IN THE DRAWINGS

This amendment responds to the Office action of September 10, 2007. Applicants amend claims 1, 2, and 14. Claims 1-29 and 34 are pending. Applicants appreciate the PTO interview of March 6, 2008 and request reexamination and reconsideration of the application.

FIGURE 1 - Prior Art

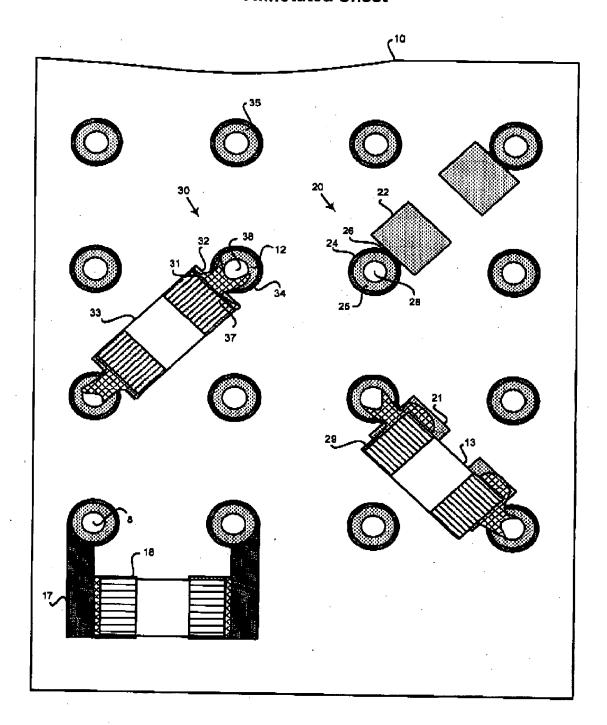
- 2 The enclosed replacement sheets are intended to replace the original sheets of Figure 1
- 3 and 2A-2B. Applicants designate each of the enclosed annotated sheets of Figures 1
- 4 and 2A-2B with the legend "prior art."

The Examiner also suggests Figures 1 and 2A-2B be designated prior art. Applicants 10 designate drawing Figures 1 and 2A-2B as prior art. 11
